SAFETY EVALUATION
FOR
VALIDATION OF BECHTEL COMPUTER CODE SASSI FOR APPLICATION TO
WATTS BAR NUCLEAR PLANT SOIL-STRUCTURE INTERACTION ANALYSIS
TENNESSEE VALLEY AUTHORITY (TVA)
WATTS BAR NUCLEAR PLANT (WBN) UNITS 1 AND 2
DOCKET NOS. 50-390 AND 50-391

2.0 PURPOSE AND SCOPE

Fig. 11 5% Damping Response Spectra of Recorded Ground Motions at Different Depths at Station DHB, Event LSST07 (Ref.7)

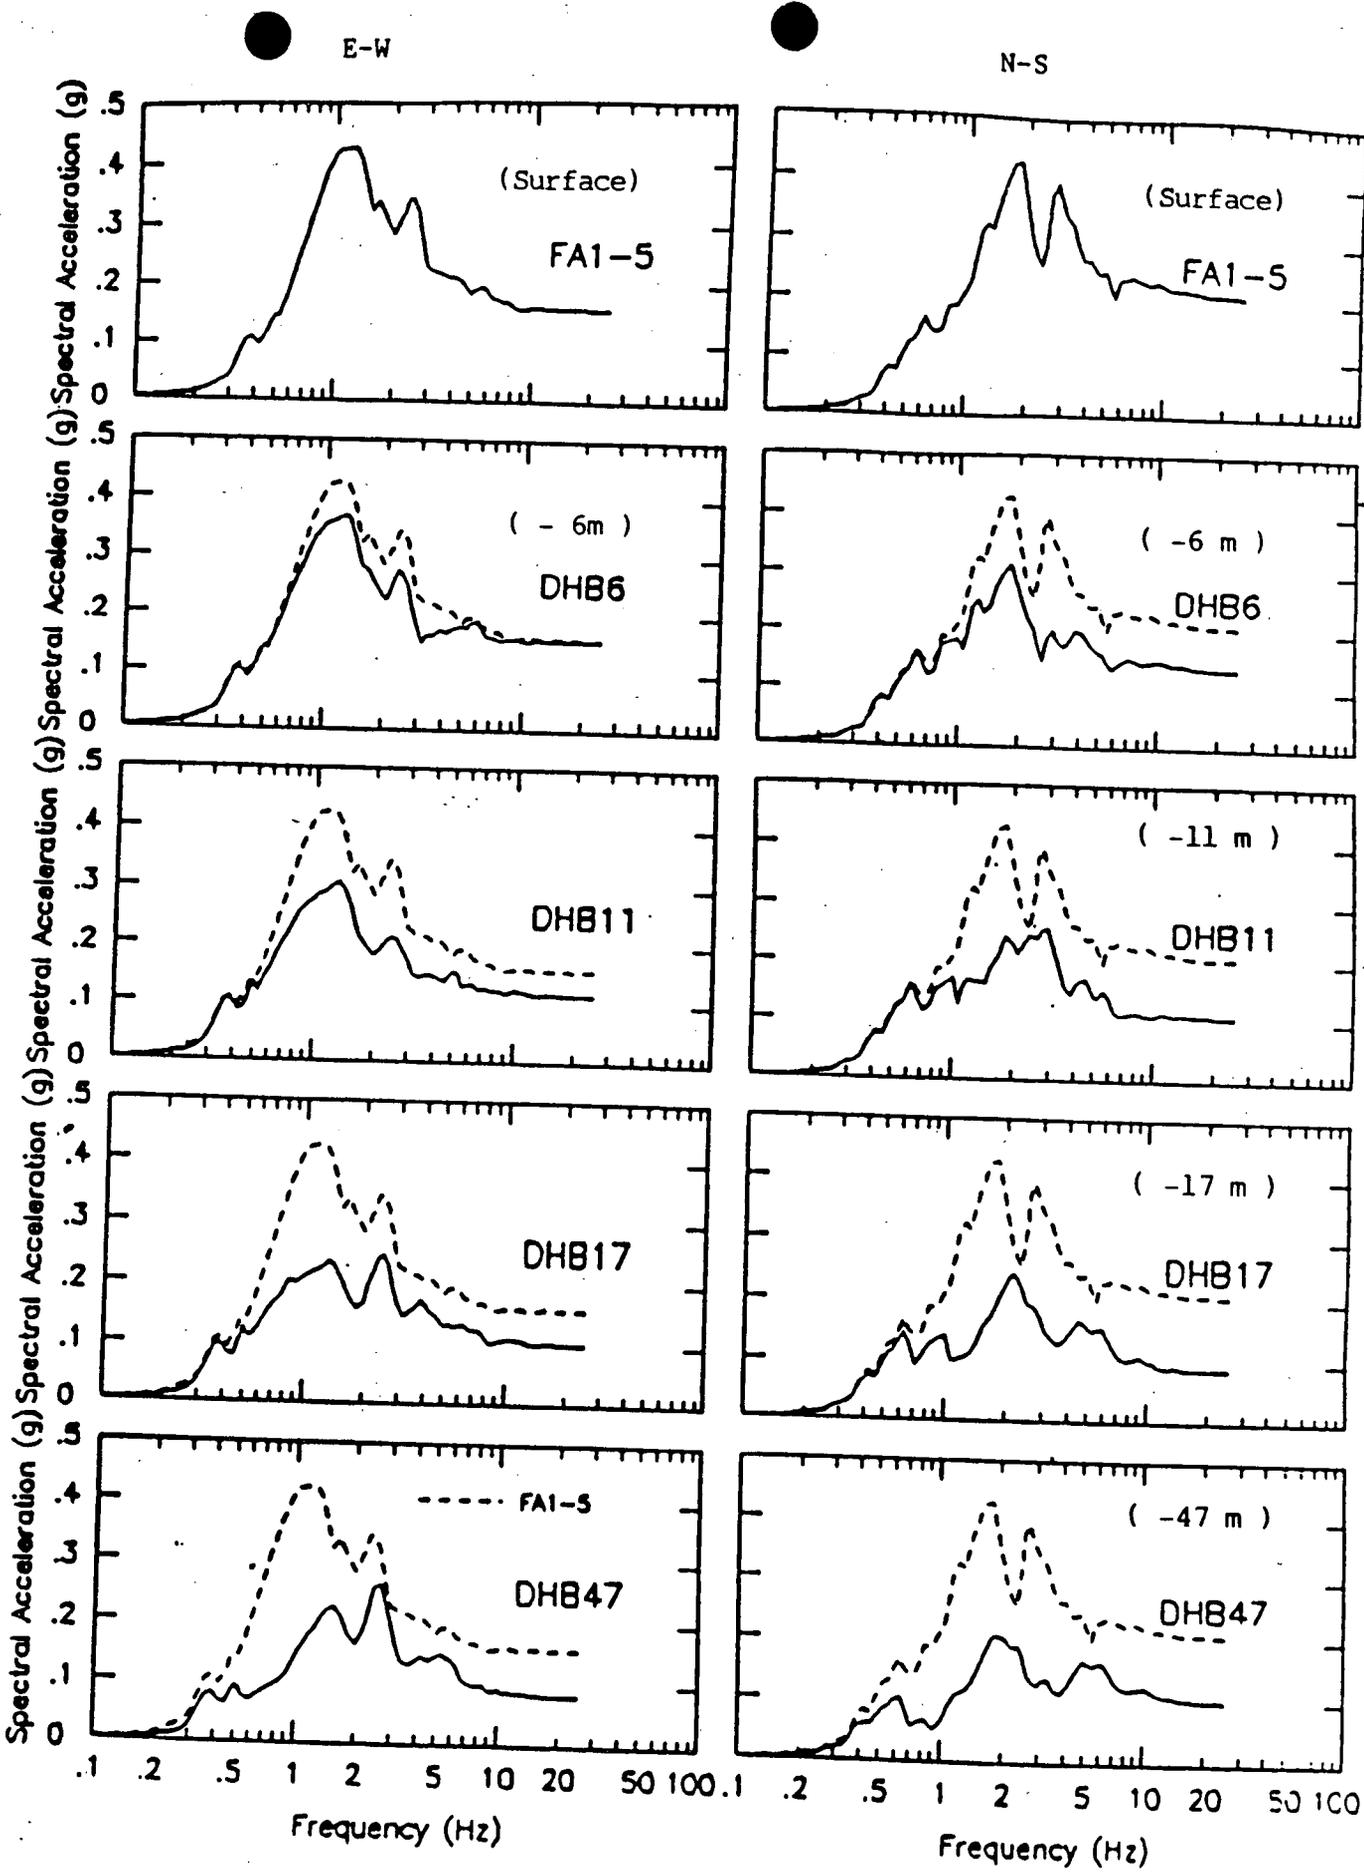
- (5) As discussed previously in finding (3), the staff and consultant noted the significance of wave scattering on the response of the DGB and RWST due to the structural embedment. The spectrum comparison for motions A, B and D as shown in Fig. 9 led to the same observation. As an additional evidence, Bechtel provided a summary of the results from some published studies on the responses recorded in and around a 1/4-scale containment model during several strong-motion earthquakes (Ref. 7). The scaled model is located in Lotung, Taiwan, and is moderately embedded in a soft soil foundation. Fig. 10 illustrates the vertical cross section of the scaled containment model. Fig. 11 shows the variation of the recorded free-field motions from the surface to -47m in the ground during one of the earthquakes. The earthquake,

denoted by Event LSST07, took place on May 20, 1986. Relative to the surface motion, a reduction in response spectrum is noticeable at -6m, which is about the same elevation as that of the bottom of the basemat. Reduction in the NS direction is more pronounced. Fig. 12 provides a spectrum comparison for the recorded and computed motions at the top of the basemat for Event LSST07. The computed motion was obtained using the CLASSIF code both with and without considering the effect of foundation scattering (or kinematic interaction). For the case including the effect of wave scattering, the scattering functions were generated from a SASSI analysis. Fig. 12 suggests that wave scattering due to the structural embedment is important to the interpretation and correlation of the SSI response recorded in the containment model. The effect of wave scattering is more pronounced in the NS direction, which is consistent with the larger reduction in free-field motion taking place at -6m in the NS direction.
